Pre-Application Consenting Memo

Pre-Application No. PRR00031670		
Date of request	10/06/2019	
Customer	Ryman Healthcare	
Contact details	Phone	Karen Joubert; 0211089447
	Email	karen.joubert@mitchelldaysh.co.nz
Site address	223 Kohimarama Road Kohimarama Auckland 1071 and 7 John Rymer Place

ATTACHMENT 2: MARK UPS

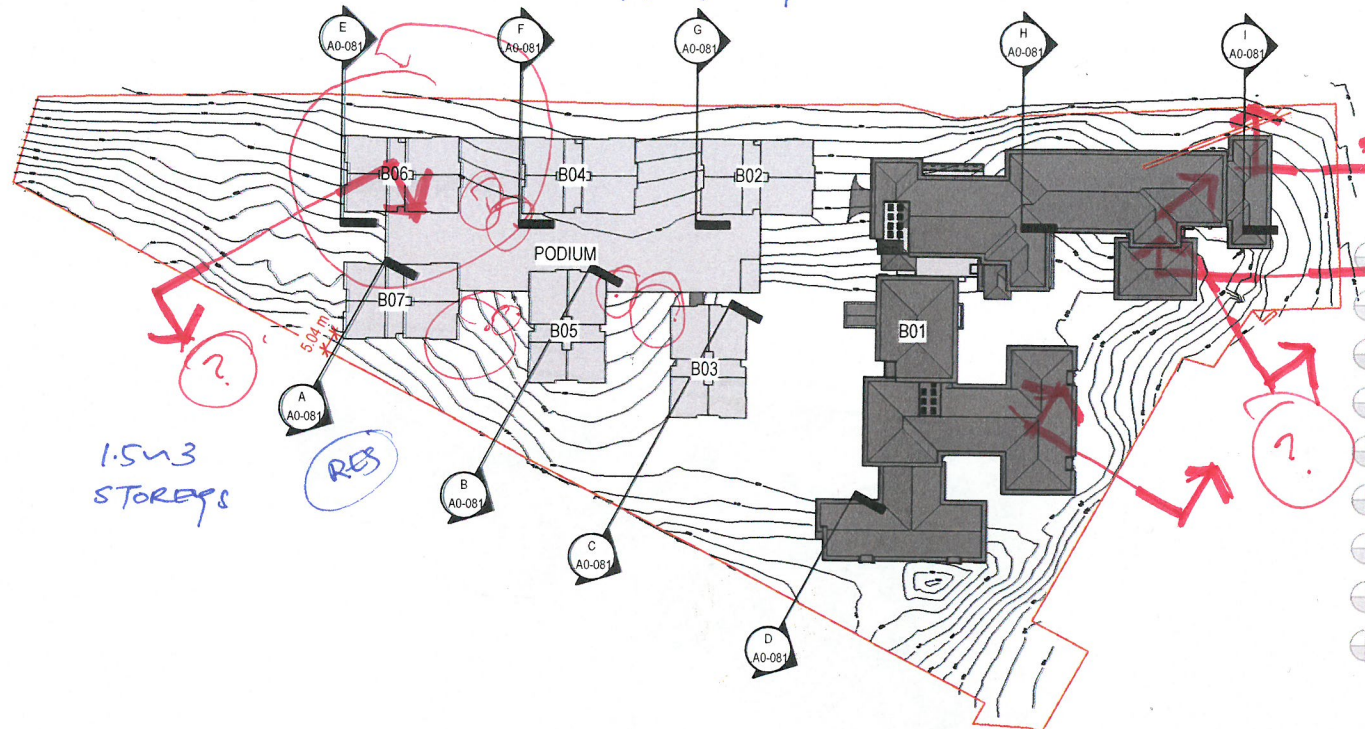
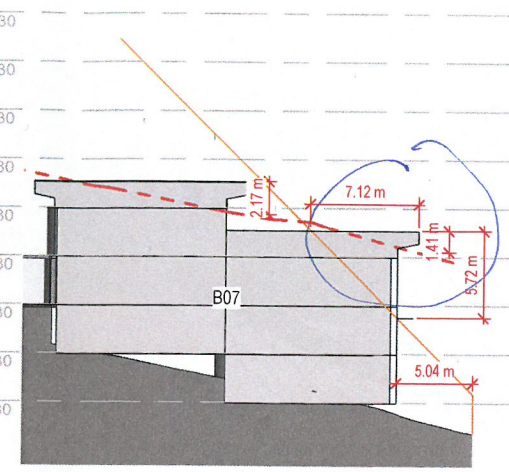
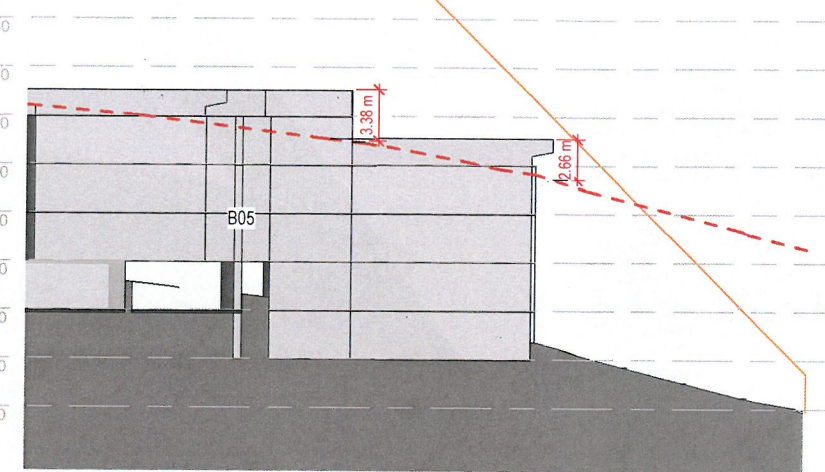
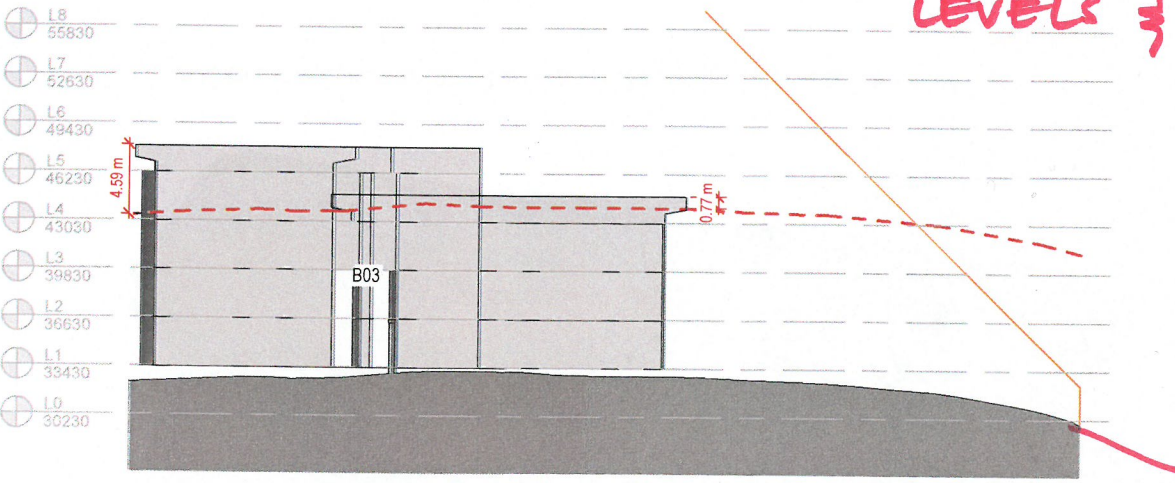
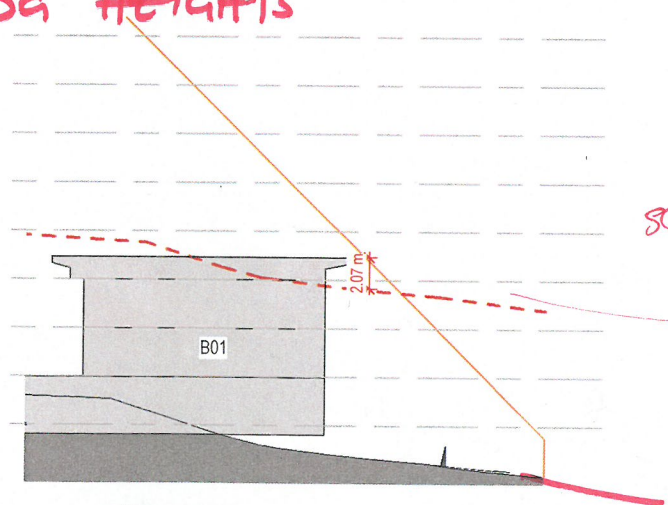
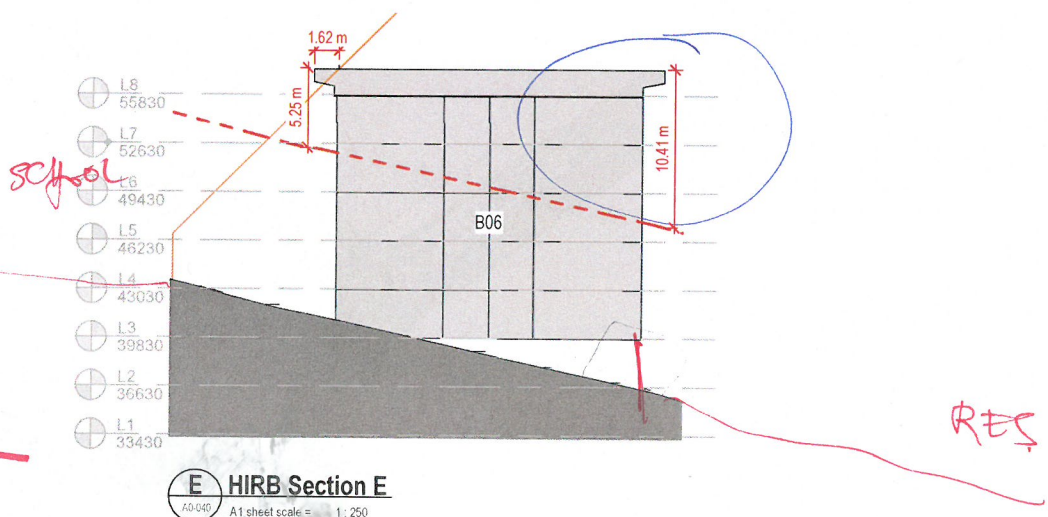
* INCLUDE ADJOINING SITES' BLDG HEIGHTS
